Access Audit – SH College, Thevara

17th October, 2011

Introduction

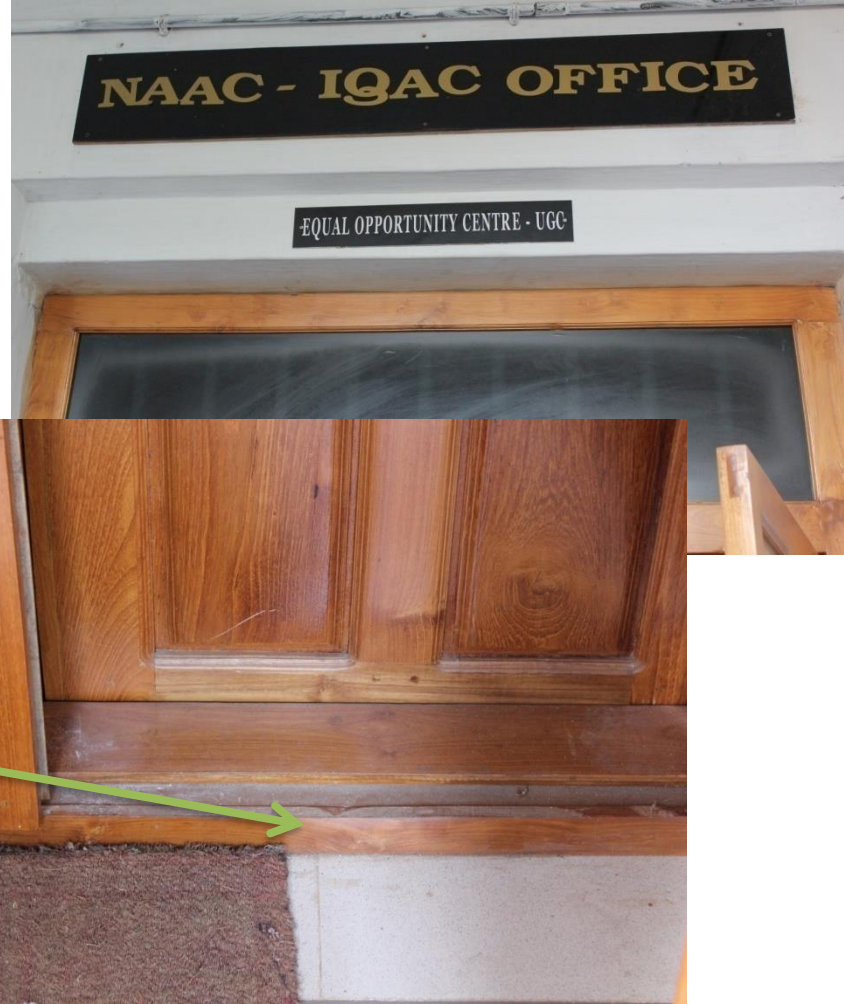
Though the ramp is there in the main entrance, it is insufficient to its purpose. The level difference in the beginning and the end is to be merged to provide unhindered access to wheelchair users.

Threshold/height difference between corridor and room height is more than 10mm in all doors – it should be reduced or the threshold is removed.

IQAC
office/Equal
Opportunity
Centre –
threshold height
is 41mm

There is no ramp in the main entrance. It would be good if the college could provide a ramp in the main entrance – this would provide an easy access to the portico from porch area.

The height of the information counter and fee counter make these counters inaccessible to the PwDs. A part of the counter can be lowered down so that the PwDs can access it easily.

On the stairs – handrail is provided only on one side of the stairs.

Handrails in contrast colours should be provided on both sides of the stairs at two levels - 700mm and 850mm. it should extend beyond the first and last step also. Round handrails with 30mm diameter in the lower one and 45mm for the top. If possible steps' edges to have colour contrasted band 50mm, which benefits person with low vision to make out the depth and height of each step.

Nosing of
steps can be
avoided.

Gaps/holes in the side walls should be covered properly

Signboard in
Braille script
can be
provided in
each floor.

Height of the coin box
phone should be
lowered.

Height of the handrails
to the gents' toilet should
be increased.

A two line handrails can
be provided.

Small gutters
for drainage
facility should
be covered.

Because of these steps, the gents' toilet on the 2nd floor is inaccessible to PwDs. There can be an extra toilet for the PwDs.

The width of the toilet is not sufficient for a wheel chair.

Steps to the girls' toilet on the 3rd floor make the toilet inaccessible to PwDs.

Grab bar should be
fixed in the toilet
No flushes in the
toilets. An additional
accessible toilet can
be provided.

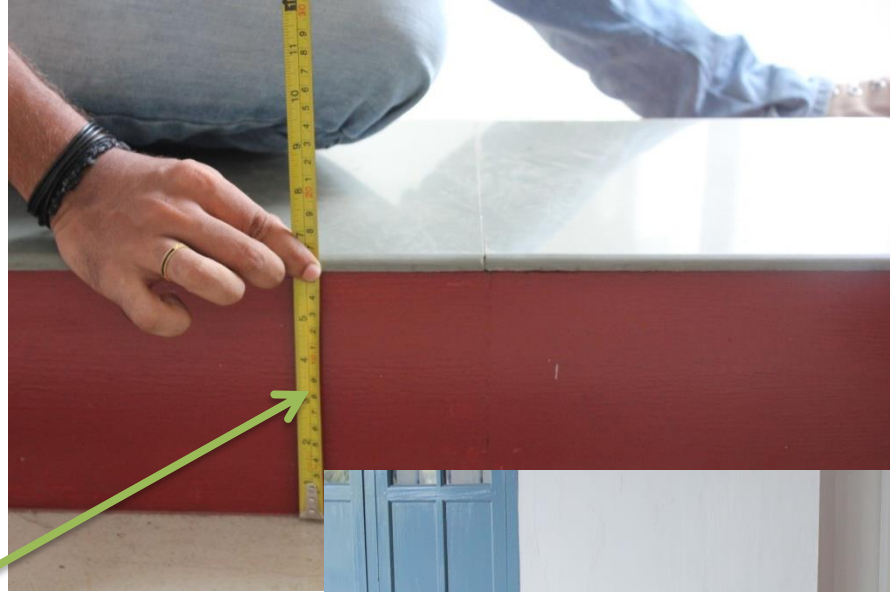
Level difference between
corridors and classrooms is
more than 10 mm in all
classes

Threshold in the
sociology
department

Beam in front of the
sociology and
commerce departments
– dangerous

No glass holder
near the water
cooler.
Inaccessible for
PwDs

There is no access to a
person with physical
disability to the main
auditorium stage

Showcases and notice boards in the corridors are dangerously protruded out from the wall

At least one of the working tables in the practical labs and computer lab should be lowered.

Projections on the corridor leading to class room can be removed.

Gutters on the bridge
between main building
and north building
should have proper
covering

Pots on the
bridge

Steps on the way to botany practical lab make the lab unreachable.

Steps on the two
ends of the bridge
between the main
building and north
building

Height of the railing near the steps of botany department should be increased.

No parking space for
PwDs in the parking
area.
